SUBJECT: ZION NUCLEAR POWER STATION, UNITS 1 AND 2 - REQUEST FOR  
ADDITIONAL INFORMATION RELATED TO PARTIAL SITE RELEASE AND  
RECENT SITE SURVEY ACTIVITIES (EPID L-2020-DSR-0000)

REQUEST FOR ADDITIONAL INFORMATION

PARTIAL SITE RELEASE REQUEST AND RECENT SITE SURVEY ACTIVITIES

ZION NUCLEAR POWER STATION, UNITS 1 AND 2

**Figure 4 - SUs Associated with the Power Block Subject to Confirmatory Surveys  
(Figure 3.1 in ORISE Survey Report 5271-SR-07)**

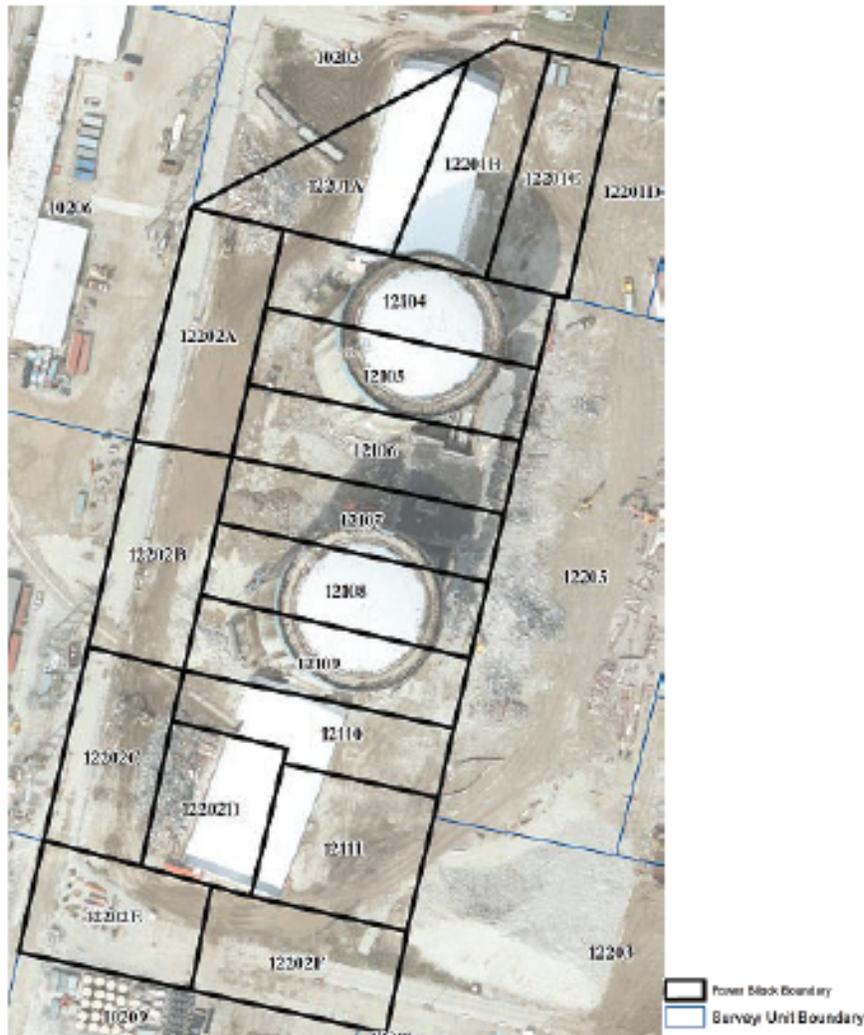
**Comment:** Observations from the April 2021 inspection survey are indicative that the thickness of clean cover in certain areas of the site are not consistent with the Zion LTP commitments, the assumptions for deriving the basement DCGLs, and the description of the end state of the site included in Phase 4 of the Zion FSSR. Information is needed by the NRC staff to verify that the cover material is consistent with the assumptions included in the Zion LTP and the final site description in Phase 4 of the Zion FSSR.

subsurface soils surrounding the former Zion containment buildings in July and August of 2019. The Phase 4 FSSR describes how “three small particles of radioactive material were identified by the ORISE survey. The particles were captured and removed. Shortly thereafter, clean fill was acquired from an off-site source and used to increase the grade of all survey units surrounding any end-state basement to the 591-foot elevation.” Therefore, as described in the Phase 4 FSSR, the layer of soil from the 588-foot elevation to the 591-foot elevation for the portion of the Zion site referred to as the “power block” is expected to contain three feet of clean fill material from an offsite source in the end state.

Figure 4 below, reproduced from the ORISE Survey Report (5271-SR-07 Zion Sacrificial Sub-Soil), shows the SUs with 588-foot indigenous soils that received confirmatory survey in August 2019. Note that SU 12201B is located directly north of the Zion Unit 2 containment.

Further observations and samples collected during the April 2021 inspection survey also call into question the thickness of the clean cover material in the final Zion site configuration. For example, limited samples were collected in April 2021 from the area where erosion was documented in the referenced CR, but some samples that were collected in SU 12204C near the border with SU 12204B and SU 10223 (beach area) contained unexpected radionuclides. Specifically, Sample S0135 and Sample S0130 contained Eu-155. It is unclear why europium is present in this area, as europium indicates activated concrete and is not expected in the Zion soil. It is also unclear if the samples represent backfill material or material that was placed on top of the clean fill material that was used for final site grading.

- b. For the areas of the site directly above backfilled basement structures (including the ZNPS Crib House basement in SU 12204), verify that the thickness of the clean cover material between the land surface and the upper level of the basement fill material is consistent with the Zion LTP commitments and the description of the site end state in Phase 4 of the Zion FSSR.

- c. Justify how current site conditions are consistent with Zion LTP. If the Zion site conditions are not consistent, discuss the intended path forward (e.g., a license amendment to revise the assumptions in the Zion LTP) to resolve the inconsistency.

- d. If the thickness of the clean cover material is less than that assumed in the Zion LTP, or the erosion rate is greater than what was assumed in the RESRAD dose modeling for the Zion site, provide an evaluation of the dose resulting from the material in the Zion basements structures with the lower amount of shielding/dilution.
